KWM-380 TRANSCEIVER (622-5093-001, -101)  
HF-380 TRANSCEIVER (622-3580-001, -101)

**SERVICE BULLETIN NO 11****ADD RCV AUDIO LOW-PASS FILTER**

The change made by this service bulletin is a product improvement. The audio response of the receiver is improved by adding an electronic low-pass filter with a 3-kHz cutoff point to reduce high frequency hiss. The filter is an active 5-pole elliptic function low-pass filter placed just before the rcv audio gain control. The filter has no effect on the 300- to 3000-Hz passband but rolls off very rapidly above 3000 Hz.

Transceiver, Bottom View  
Figure 1

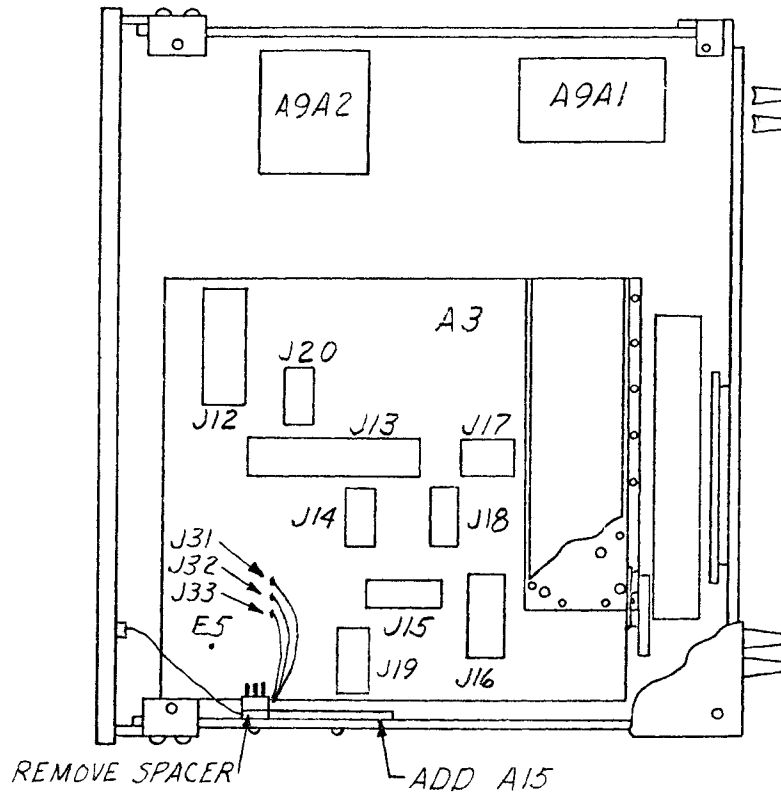
- E. Remove spacer as shown in figure 1.
- F. Install mounting bracket and circuit card A15 (step D) into transceiver using screw where spacer was removed and one additional screw (343-0167-000) in an existing hole in chassis.
- G. Inspect receiver-exciter card A3 to determine if W3 is connected from R713 to E5 as shown in figure 3. If this wire has been installed, proceed to step N. If W3 is not present, perform steps H through M.
- H. Lift the left-hand lead of 180- $\Omega$  resistor R713 and install a square pin (372-2601-045) from the top of the card into the hole vacated by the lead. Solder the square pin.
- I. Reconnect the R713 lead to the square pin.

Low-Pass Filter Card A15

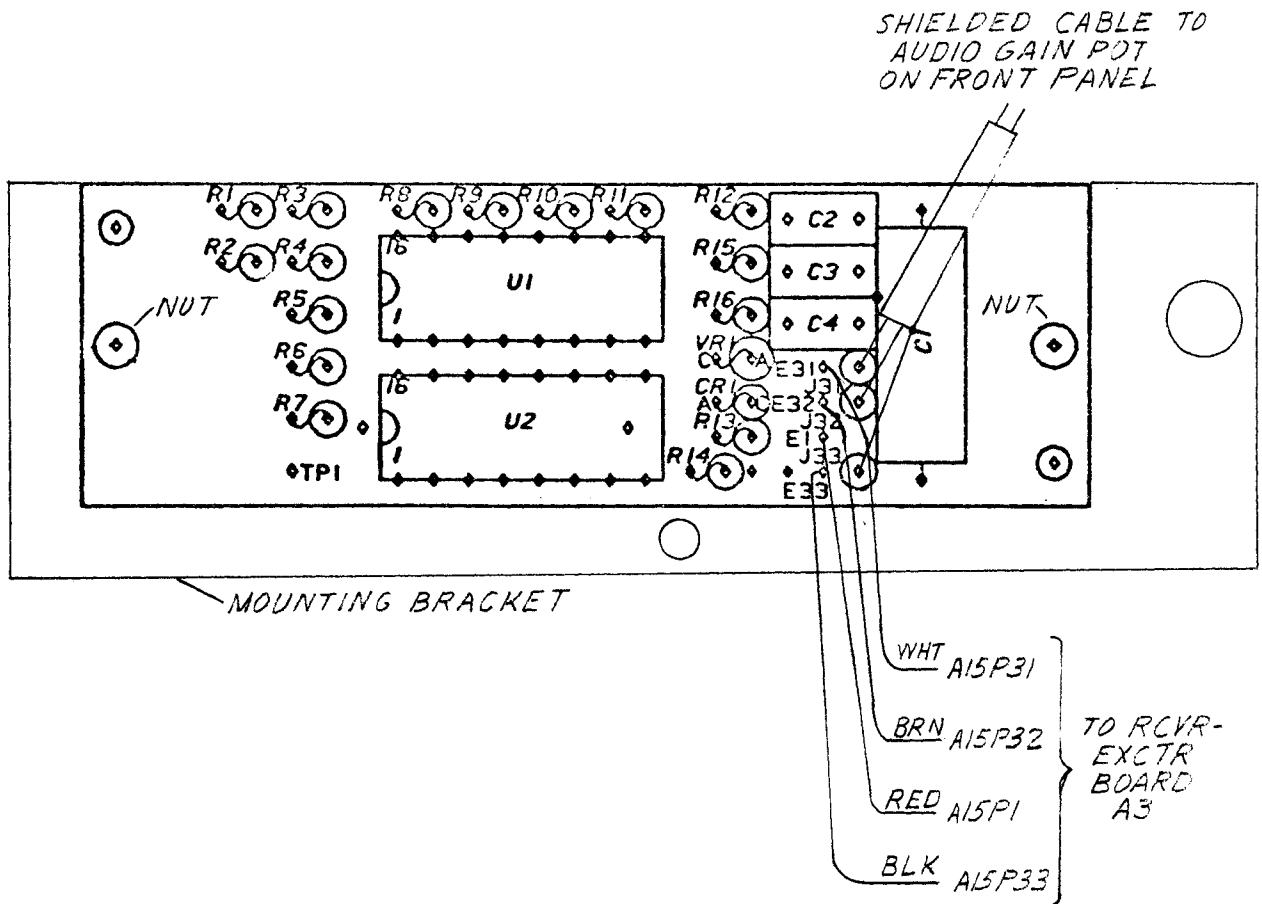
- D. Install filter circuit card A15 (646-5802-001) onto mounting bracket (647-2929-001) using two hex nuts (333-1299-000). Refer to figure 2.

P/O Receiver-Exciter Card A3  
Figure 3

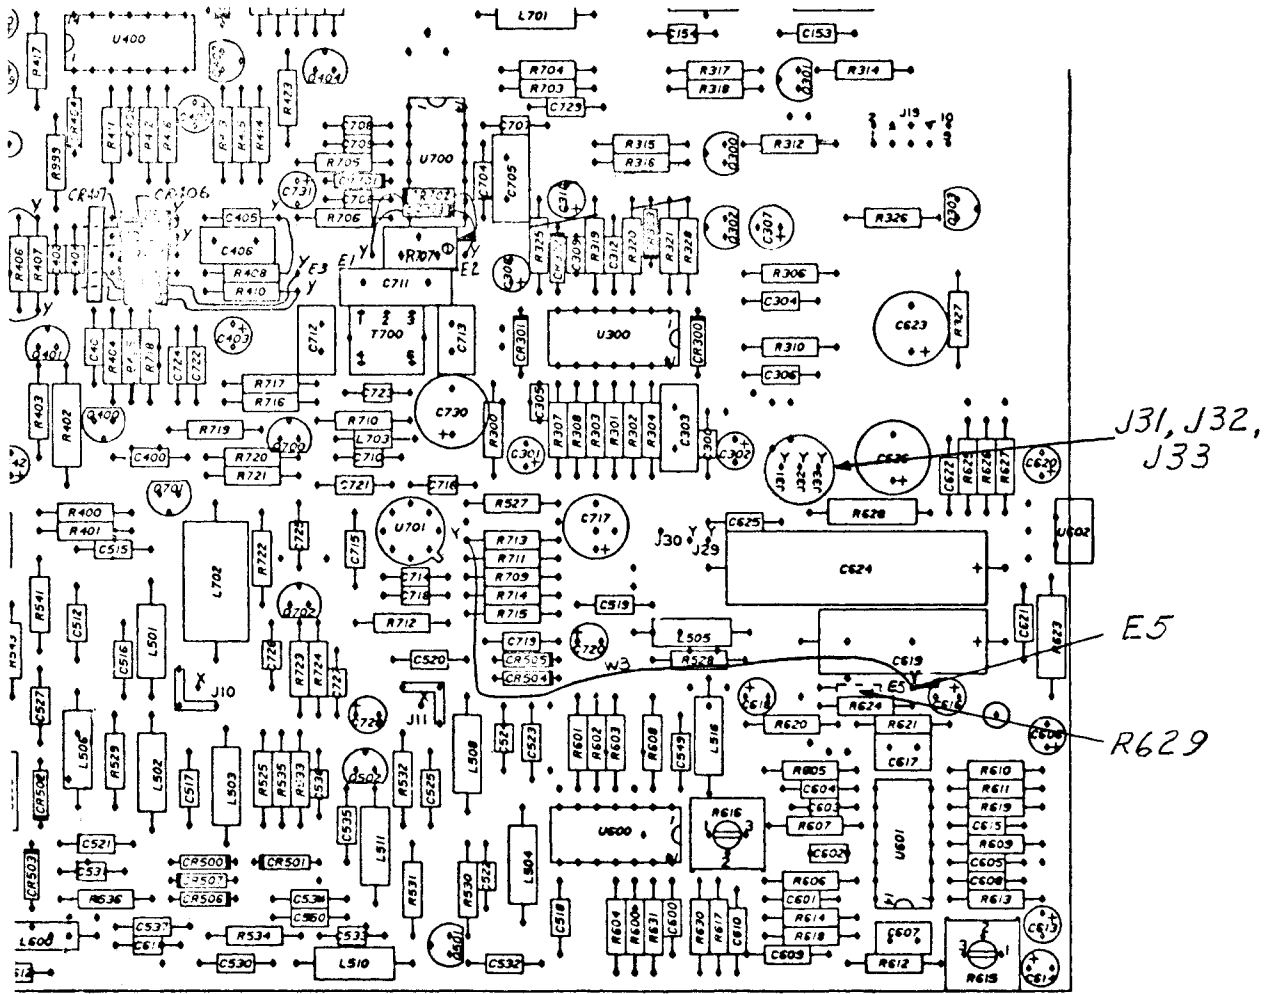
- J. Remove and discard 100- $\Omega$  resistor R629.
- K. Insert a square pin (372-2601-045) from the top of the card at E5 (right end of R629) and solder.

- L. Connect one end of W3 (421-0023-000) to the square pin at E5. Insulate this wire with sleeving (152-2643-000).
- M. Connect the other end of W3 to the square pin at R713.

Audio Low-Pass Filter Assembly A15, Schematic Diagram  
Figure 4

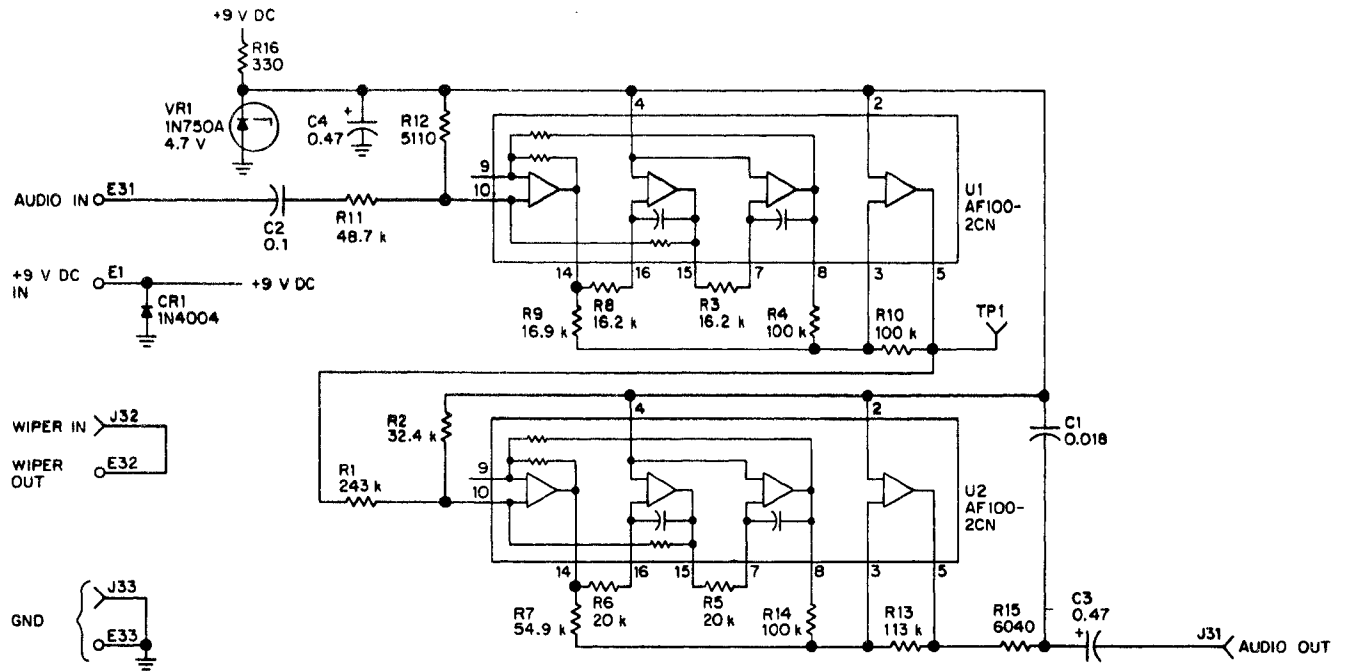
NOTE: Refer to figures 1, 2, and 3 while performing steps E through M. Refer to figure 4 for a schematic diagram of the new filter card A15. Refer to figure 5 for schematic diagram changes to receiver-exciter card A3. Refer to figure 6 for interconnect diagram changes.

P/O Interconnect Diagram  
Figure 6

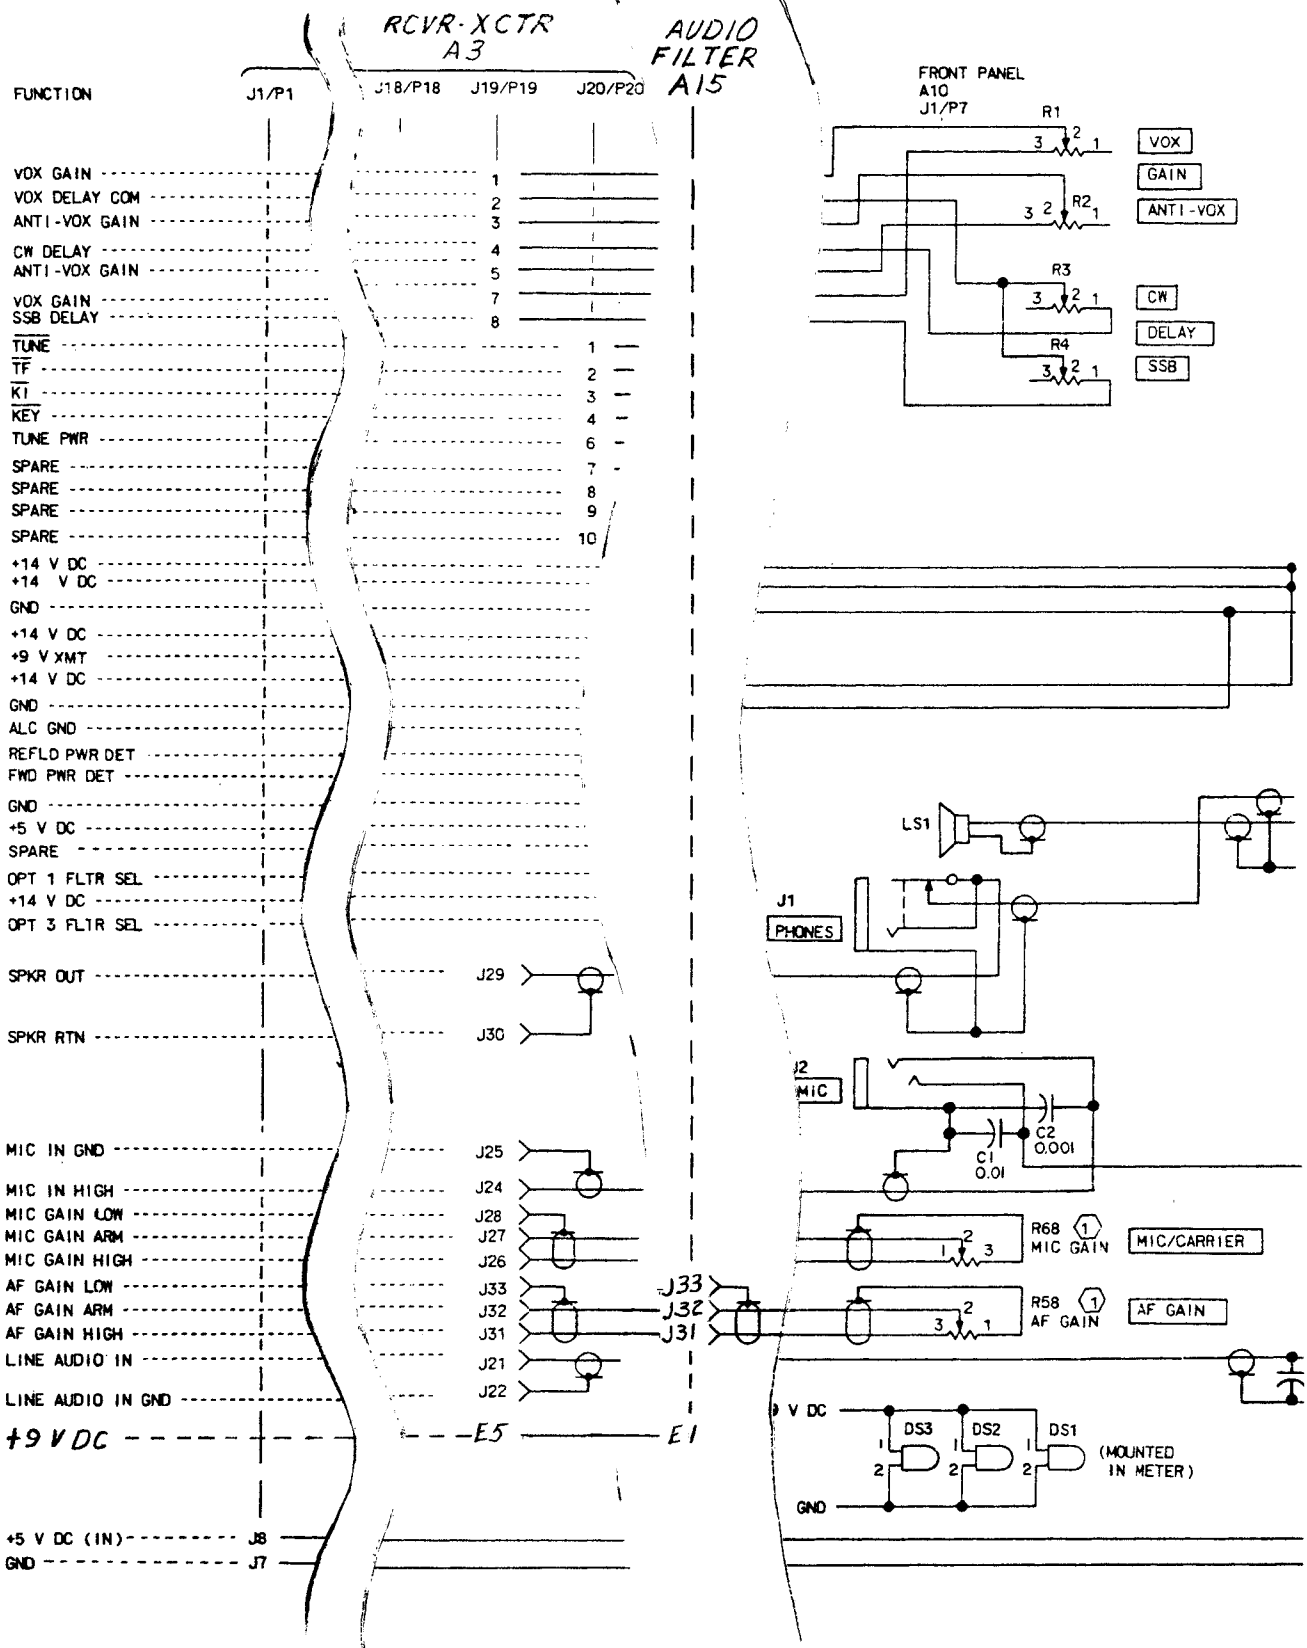
- N. Disconnect the leads from A3J31, A3J32, and A3J33. Connect the white lead to A15J31, brown lead to A15J32, and black lead to A15J33. This connects the front panel audio gain pot to the low-pass filter card A15.

- O. Connect A15P31 (white lead) to A3J31, A15P32 (brown lead) to A3J32, and A15P33 (black lead) to A3J33. This connects the low-pass filter card A15 to receiver-exciter card A3.
